CERTIFICATE OF APPROPRIATENESS

Property: 2110 State Street, Lot 3, Block 408, Baker W R NSBB Subdivision. The property includes a historic one-story wood frame single-family residence situated on a 5,000 square foot (50' x 100') interior lot.

Proposal: Alteration – Revise a COA granted in June 2014 to allow vinyl 2-over-1 windows with snap-on exterior muntins instead of the approved wood 2-over-1 windows on a new rear addition. The applicant has installed flush-mounted vinyl windows with internal muntins. See enclosed application materials and detailed project description on p. 5 -13 for further details.

WEST SIDE ELEVATION

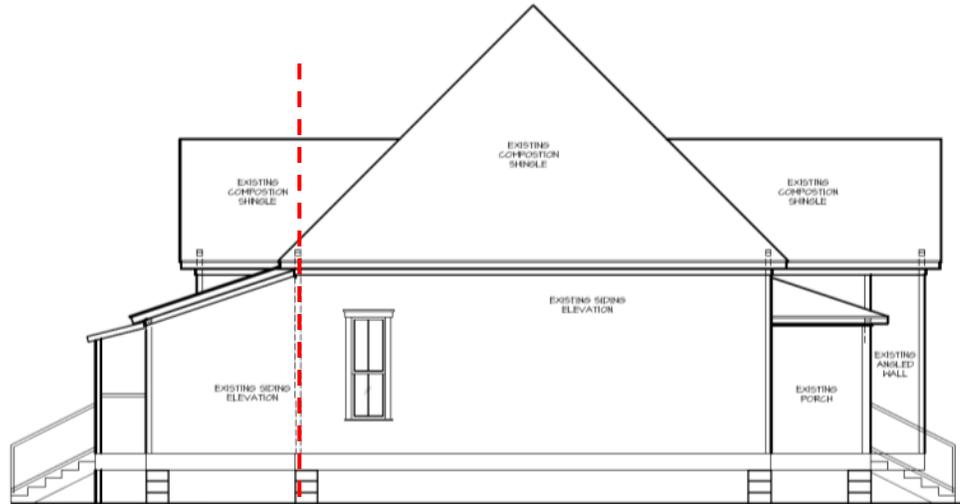
The windows on the west elevation of the addition should be traditionally mounted 2-over-1 or 2-over-2 windows with true divided lights or 1-over-1 windows. Vinyl profiles that resemble traditional wood window profiles are acceptable per the OSW Design Guidelines.

Side Elevation: The addition was approved for wood, double-hung 2-over-1 windows measuring approximately 2' wide by 4' tall and 3' wide by 6' tall. The revision makes these two windows vinyl with a 2-over-1 lite division with an exterior snap-on muntin to give them an appearance of a true divided lite. The trim is 3/4" thick.

WINDOW COMPARISON

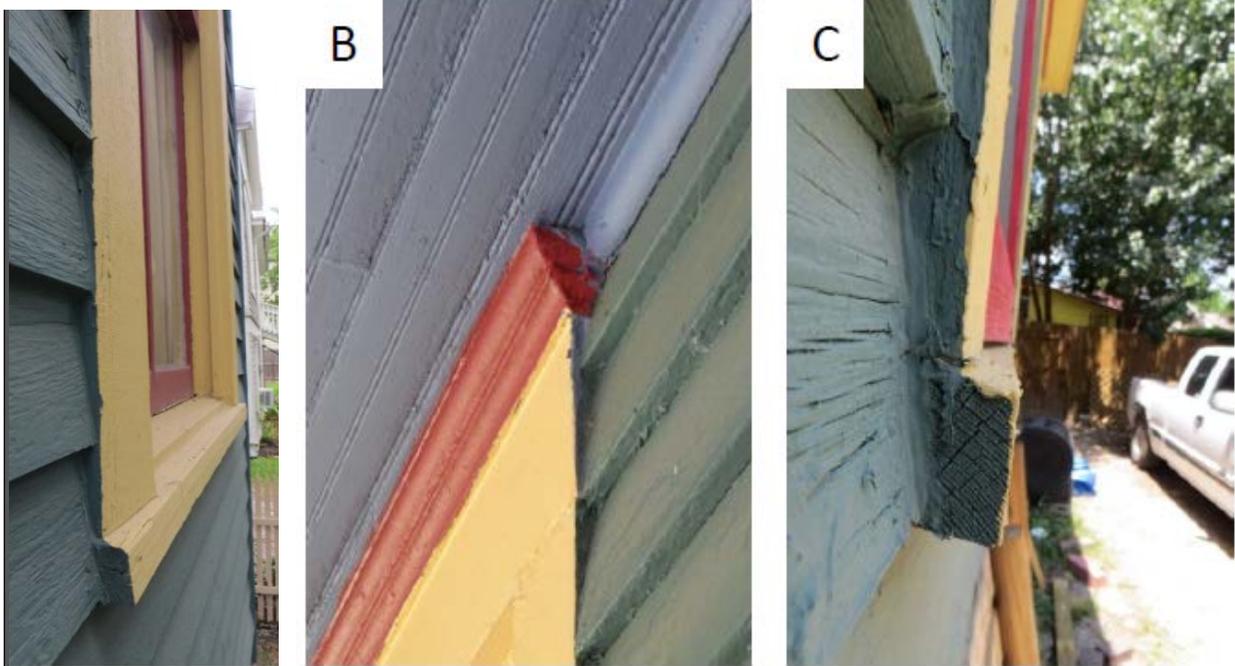
<i>Traditionally mounted and truly divided lights are distinctive stylistic features of the building and are examples of skilled craftsmanship. The proposed windows are flush-mounted with false exterior muntins, which are not compatible with the existing building's features.</i></p> |

*INTERNAL MUNTIN - PROPOSED WITH SNAP-ON EXTERIOR
MUNTIN
VINYL
FLUSH MOUNTED WITH BUILT-OUT TRIM*

TRIM COMPARISON

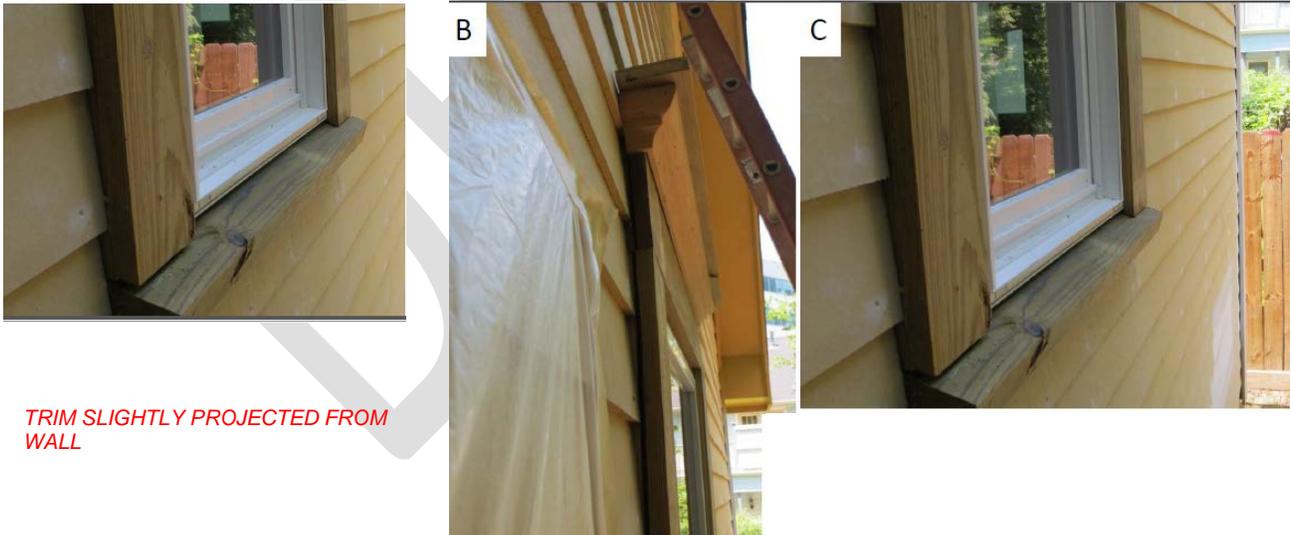
TRIM SLIGHTLY PROJECTED FROM WALL
